The Arcade and 18-20 Corporation Street and 17 Foundry Street, Dewsbury

Summary of Amendments

Doc No. 1705-BDP-AD-XX-RG-Z-00005
Revision: P01
Date: 18 June 2026

1 Ground Floor Plan_Proposed
1 : 100

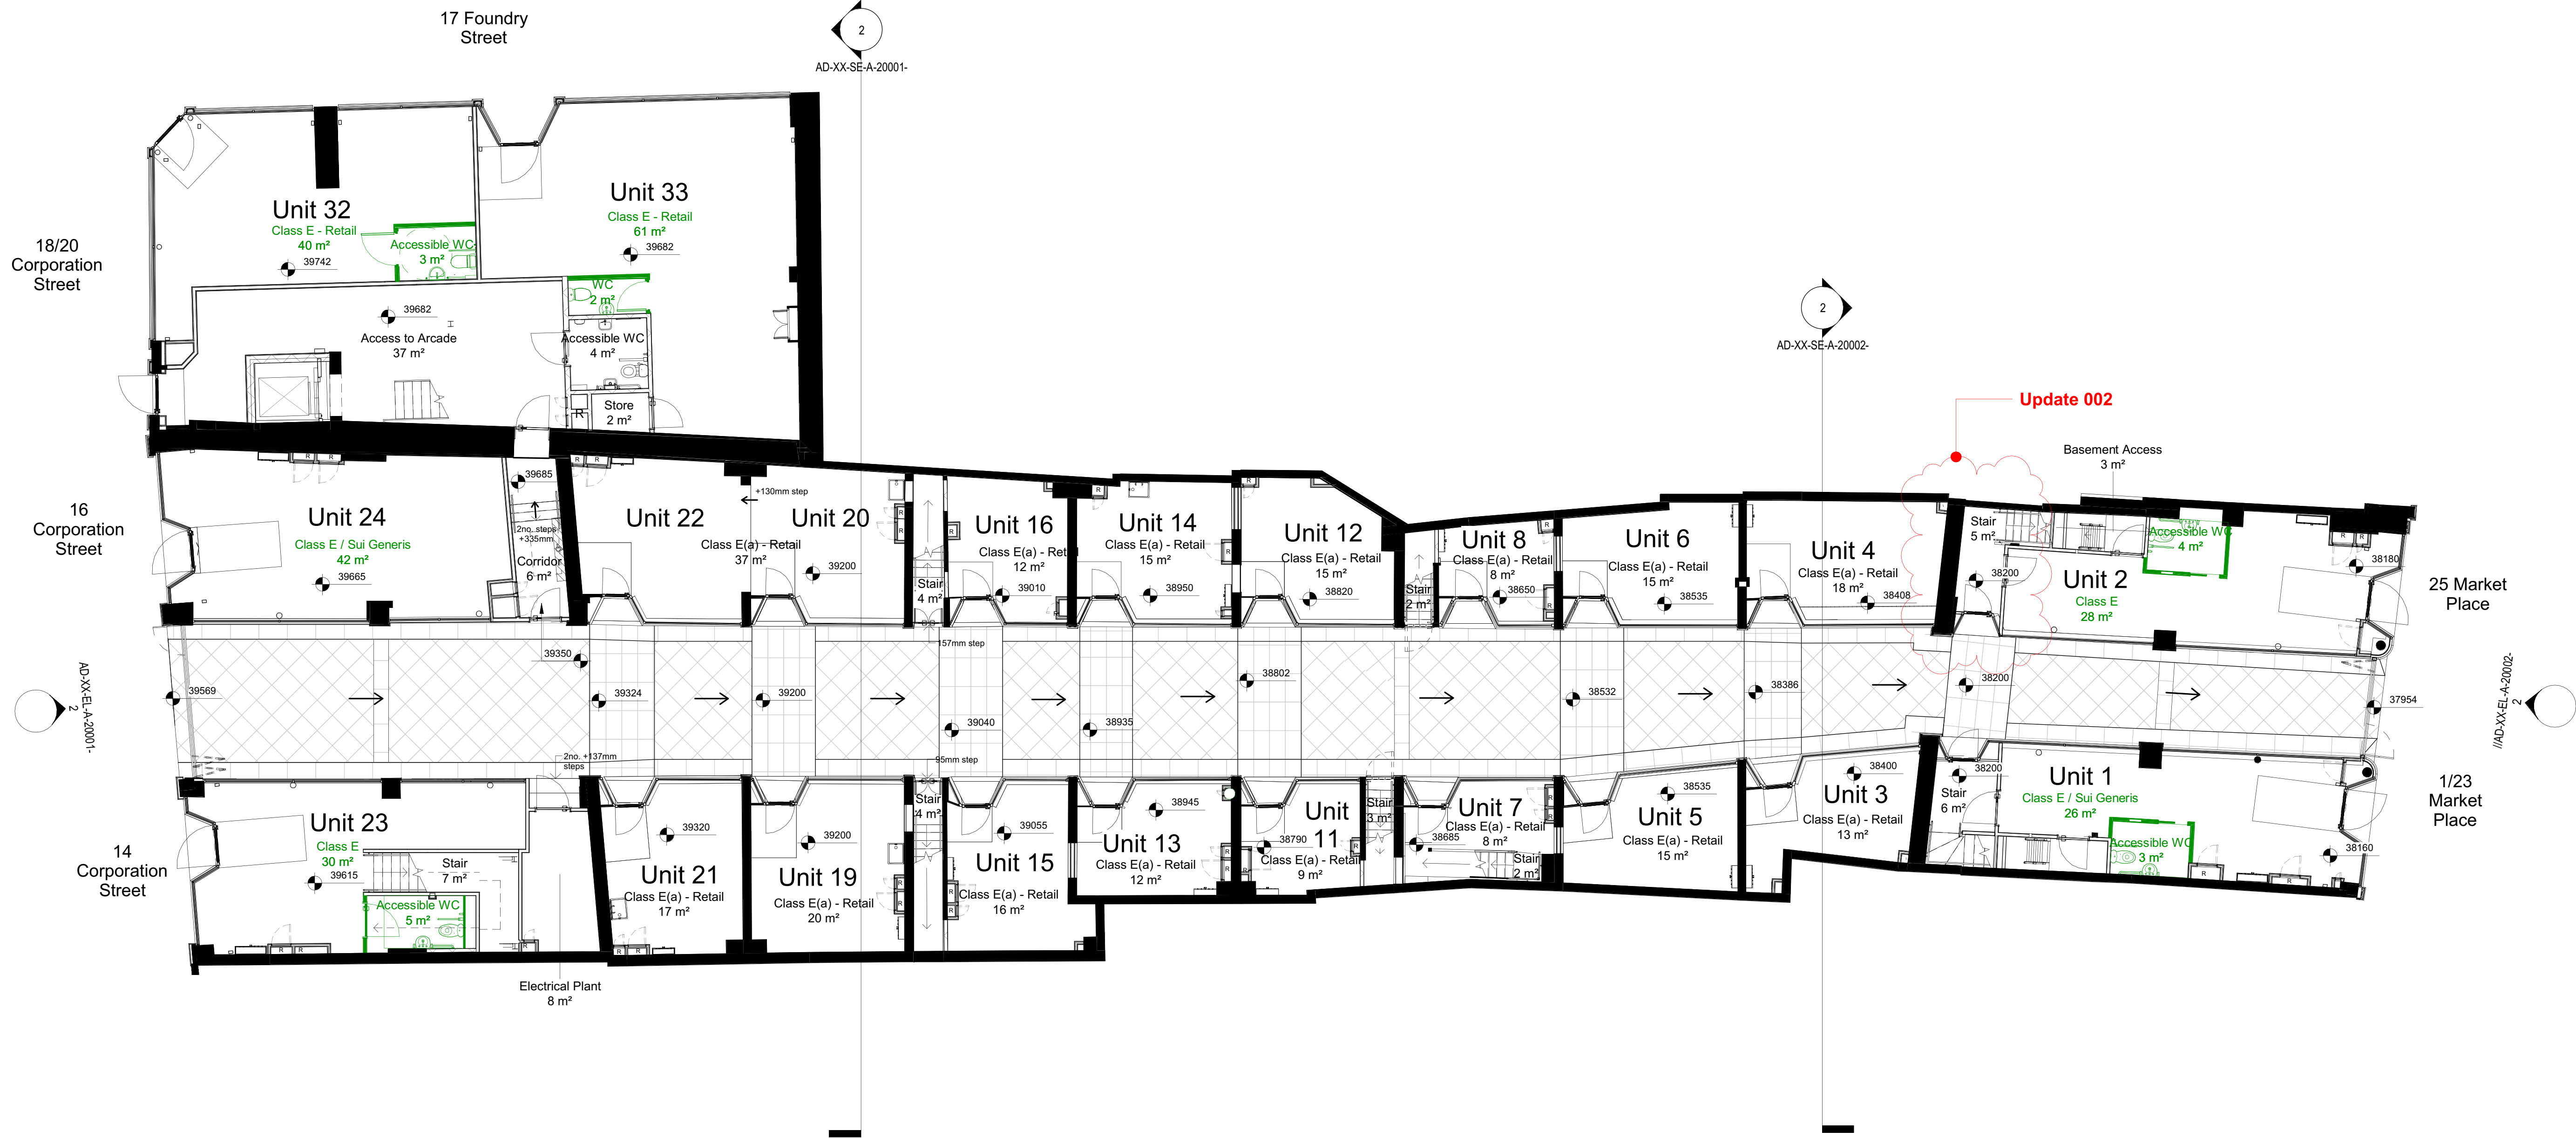
Location	Element	Original proposals	Difference from what was expected (where applicable)	Problem caused / Opportunity for improvement	Proposed solution	Relevant drawing/s as approved	Updated drawings
001	23-25 Market Place Units 1 and 2	Floors	Existing steel post and beams within timber suspended floor to be removed.	Existing timber floor structure was found to have wet rot, with numerous steel beams added.	The structural engineer confirmed the existing structure was unsuitable for the proposed building use.	Replace the suspended timber floor. The location of the floor below the surrounding external ground levels would make the ends of any timber joists prone to rotting (as evidenced on the existing joists and extensive unsuccessful past repair attempts). It is therefore proposed that a concrete suspended floor is installed in these two units.	1705-BDP-AD-00-PL-A-20002_T01	1705-BDP-AD-00-PL-A-20002_T02

002	25 Market Place Unit 2	Internal partitions	At ground floor, the stair would exit into unit 2.	n/a	For building regulations and fire evacuation, it is necessary for the stair exit to be separated from unit 2.	Minor change to internal layout with new partition added to separate the stair exit from unit 2.	1705-BDP-AD-00-PL-A-20001_T01 1705-BDP-AD-SL-PL-Z-00003_T01	1705-BDP-AD-00-PL-A-20001_T02 1705-BDP-AD-SL-PL-A-00003_T02
003	23-25 Market Place and 14-16 Corporation Street	Masonry walls	Existing wall to be retained.	Following the removal of modern finishes (e.g. plasterboard), several sections of wall have been found to be recent blockwork.	These blockwork infills are mostly poorly built, not meeting the fire performance requirements or modern structural requirements.	Replace poor quality blockwork infills with new, to meet modern requirements.	1705-BDP-AD-00-PL-A-20002_T01 1705-BDP-AD-02-PL-A-20002_T01	1705-BDP-AD-00-PL-A-20002_T02 1705-BDP-AD-02-PL-A-20002_T02

004	Central Arcade, 14-16 Corporation Street, 18-20 Corporation Street and 17 Foundry Street Units 3-8, 11-15, 19-24, 32 and 33	Floors	Existing floor slab to be locally removed for new building services and then reinstated.	The floor slabs in these units were found to be several thin layers of poor quality screed directly onto the soil, rather than actual slabs. The overall thickness of these layers was considerably thinner than would have been expected for a proper slab.	It would not be possible to dowel into the existing 'slabs' to reinstate areas of slab following the installation of new building services. This would be likely to lead to differential settlement between the existing areas of slab and the new infill areas.	Remove more of the existing screed layers and install complete slabs to these units, to avoid future differential settlement. This strategy has already had consent in unit 16.	1705-BDP-AD-00-PL-A-20002_T01	1705-BDP-AD-00-PL-A-20002_T02

1 First Floor Plan_Proposed
1:100

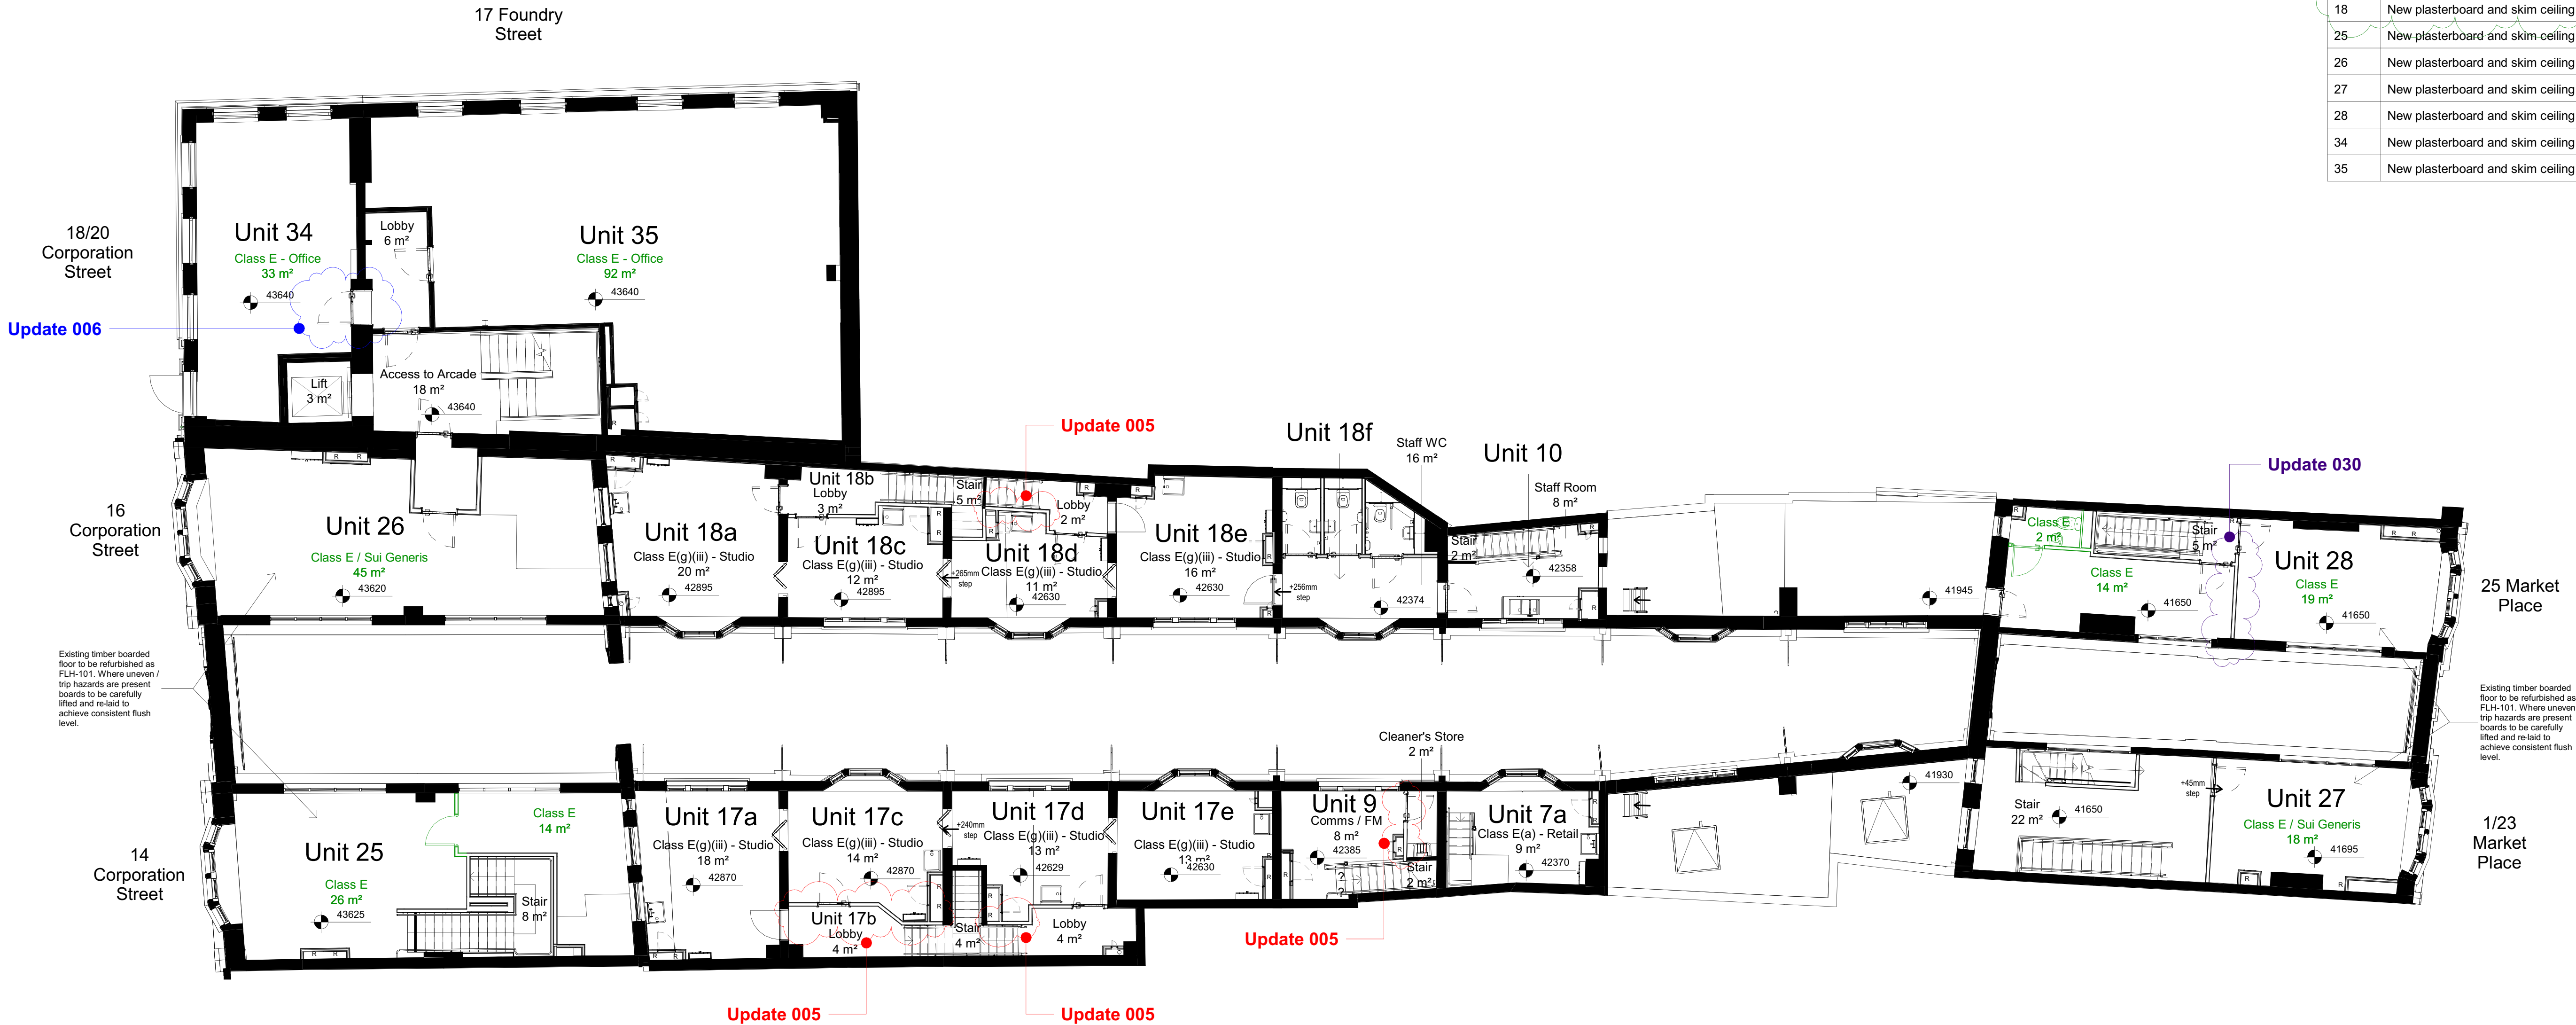
005	Central Arcade Units 9 and 17b	Internal partitions	Existing partitions were assumed to be historic lath and plaster partitions to be retained and upgraded to meet the new fire performance requirements for a 60-minute protected stairway where applicable.	The partitions were found to be a mix of more modern construction and were generally poorly built incorporating hard board / MDF.	These were not historic elements of the building, and it would not be practical to upgrade them to provide 60 minute fire resistance.	Replace these sections of partition with new plasterboard partitions to provide the required fire resistance. This is the same approach that had already had consent for the partitions forming the fire-protected stair in unit 18b on the opposite side of the arcade.	1705-BDP-AD-01-PL-A-20001_T01 1705-BDP-AD-01-PL-A-20002_T01	1705-BDP-AD-01-PL-A-20001_T02 1705-BDP-AD-01-PL-A-20002_T02

026	Central Arcade	Glazed roof structure	Cast iron trusses to be redecorated.	Cracking was noted to the top and bottom chords of several of the cast iron trusses.	The cast iron structure was unsafe in its existing condition.	Install additional steel principal rafters to carry the roof load and relieve the existing cast iron trusses of their existing load. Cast iron trusses to remain in location and be resupported from the new steel rafters.	1705-BDP-AD-RF-PL-A-20005_P01	1705-BDP-AD-RF-PL-A-27001_P02
027	Central Arcade Units 7a, 9, 10, 17, 18	Ceilings	Repair damaged lath and plaster ceilings.	The ceilings were found to be in a poorer state than expected.	The plaster had debonded from the laths and therefore was not suitable for patch repair.	Remove damaged material and replace with plasterboard. This approach has already had consent for units 25, 26, 27, 28, 34 and 35.	1705-BDP-AD-01-PL-A-20001_T01	1705-BDP-AD-01-PL-A-20001_T02

030	23-25 Market Place Units 28 and 29	Walls	Repair damaged masonry walls and replace plaster finish where irreparably damaged.	The walls were found to be a mixture of timber framing and unbonded masonry.	The walls were structurally unstable, and moved visibly when pushed.	Remove structurally unstable parts of walls and replace with new stud wall.	1705-BDP-AD-01-PL-A-20001_T01 1705-BDP-AD-01-PL-A-20002_T01 1705-BDP-AD-02-PL-A-20001_T01 1705-BDP-AD-02-PL-A-20002_T01	1705-BDP-AD-01-PL-A-20001_T02 1705-BDP-AD-01-PL-A-20002_T02 1705-BDP-AD-02-PL-A-20001_T02 1705-BDP-AD-02-PL-A-20002_T02

1 First Floor Removals Plan
1 : 100

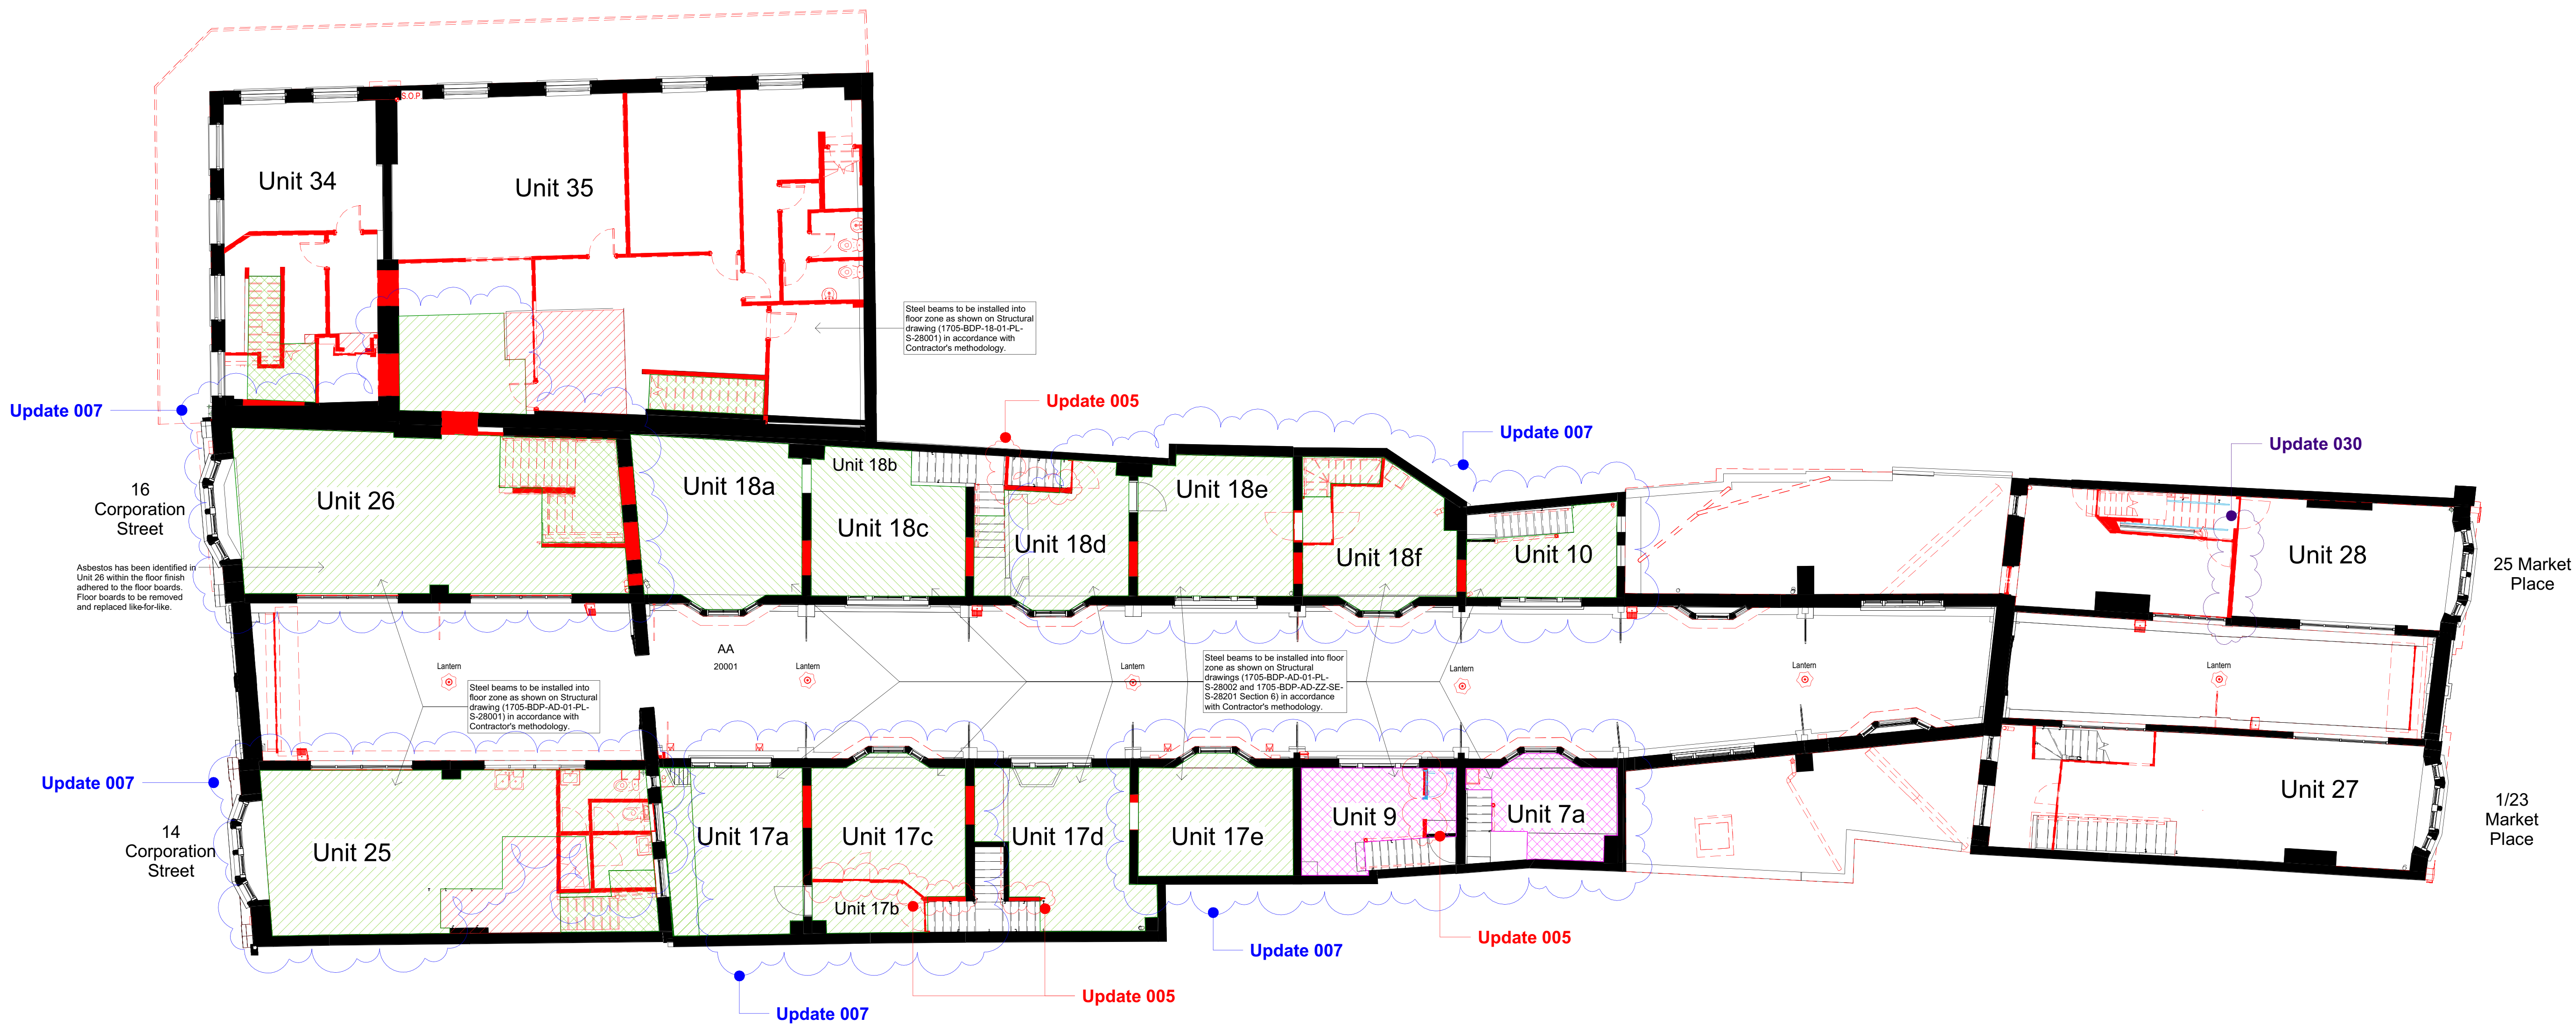
006	18-20 Corporation Street and 17 Foundry Street Unit 34 / 35	Stairwell and door	No lobby to top of stair. New door to swing outwards.	n/a	For building regulations and fire evacuation, it has been proposed that these units should be lobbied from the protected stair, and the door to unit 34 should swing into unit 34, to avoid impacting the escape route from unit 35.	Lobby added. Door to swing inwards (into unit 34)	1705-BDP-AD-01-PL-A-20001_T01 1705-BDP-18-ZZ-PL-A-00002_P06	1705-BDP-AD-01-PL-A-20001_T02 1705-BDP-18-ZZ-PL-A-00002_P07
007	Central Arcade First floor units	Floors	Units 17d, 18a, 18b, 18c and 18d: replace the floors due to wet and dry rot. Units 7a, 9, 10, 17a-c, 17e, 18d-f, 25, 26 and 35: Refurbish the floors: lift boards, strengthen and repair existing joist structure. Reinstate existing boards wherever practical and supplement with new.	Extensive wet and dry rot had already been identified in units 17d, 18a, 18b, 18c and 18d, 25, 26 and 35. Further wet and dry rot was found in the remaining units affecting the joists and floorboards.	The existing joists were damaged by wet and dry rot to the extent that strengthening them was not practicable. The floorboards were similarly damaged so that only short lengths could be recovered for reuse.	Replace the timber joist floor structure to the remaining units in the areas that have been affected by wet and dry rot (as had already been had consent for units 17d, 18a, 18b, 18c and 18d). Recover all lengths of floorboard which are suitable for reuse and install them in units 7a and 9, with new floorboards used elsewhere. This will allow two units to retain the appearance of their original floor.	1705-BDP-AD-01-PL-A-20002_T01	1705-BDP-AD-01-PL-A-20002_T02

Update 007
